NACCAI Stormwater Management Action Report to Mid Coast Council. Review 3.1 9 Feb. 2023.

A report by the Residents Association's Roads, Drainage and Signage Sub Committee on the status of progress in completing works identified in the BMT North Arm Cove Stormwater Management Strategy Report to Council (2017), following inspections by Seamus Devlin and Gary Sylvaney during October/November 2020. For a description of priority and work level required classifications, see table on last page. It is not intended to include works requests in this report that would be considered normal periodic maintenance by the local Council Depot, for example Table Drain clearing. This Report seeks to identify for Council works planning/budgeting Stormwater/Drainage issues in North Arm Cove that create damage to residential properties, council assets, topography and/or safety hazards.

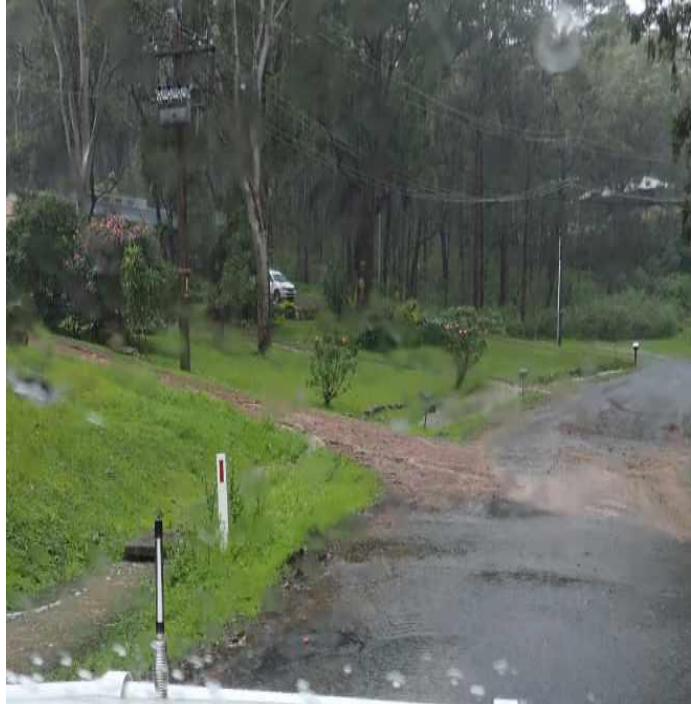
<p>8 Cont.</p>	<p>S1</p>	<p>Construct pre-treatment swale/basin and biofiltration basin in Casuarina Park.</p>  	<p>NOT DONE. May not be required. North Arm Cove for historical reasons has precious little waterfront access land available for public recreation. We believe therefore any reduction in this small area is not a positive for residents. We would like to suggest an alternative.</p> <p>The drains feeding into the Casuarina Outlet (south perimeter) are more than adequate to pass any foreseeable volume of stormwater from the northern section of Eastslope Way with 2 x 760mm ID pipes as evidenced in the 2015 and 2020 storms. One west side drain centred on the park near 61 exits to the west top end of the park. It pours onto the park and Table Drain beside new sealed entry track.</p> <p>The second pit 35 metres south stays underground and empties on the east end of the park beside the Dinghy Ramp. If the first pit drain pipe was connected to the second under-ground within the park both could exit directly beside the Ramp.</p> <p>If similar swales were constructed here as were at the Water St outlet, current problems with stormwater impacting on the Ramp and therefore restrictions on its length could be resolved.</p>	<p>C</p>	<p>3</p>

<p>8 cont.</p>	<p>S1</p>		<p>Thus, two significant problems, uncontrolled erosion of the park and inability to lengthen the Ramp to a practical and useful length would be resolved. Most importantly, the current very unsafe construction of the Ramp end would be eliminated.</p> <p>All existing Concrete pits feeding to the two main pipes including adjacent to house Nos 57, 61 and 63 should be converted to mesh style to reduce the impact of debris build-up and subsequent flow restriction.</p> <p>Currently sandbagged which ultimately further reduces the pits effectiveness.</p> <p>Heavy cross road flow into Casuarina as a consequence.</p> <p>Sealing of the track to the Ramp recently by Council has reduced the erosion flow and provided safer access. It will be interesting to record flow when the next heavy sustained rain event occurs.</p>			
--------------------	-----------	---	---	--	--	--
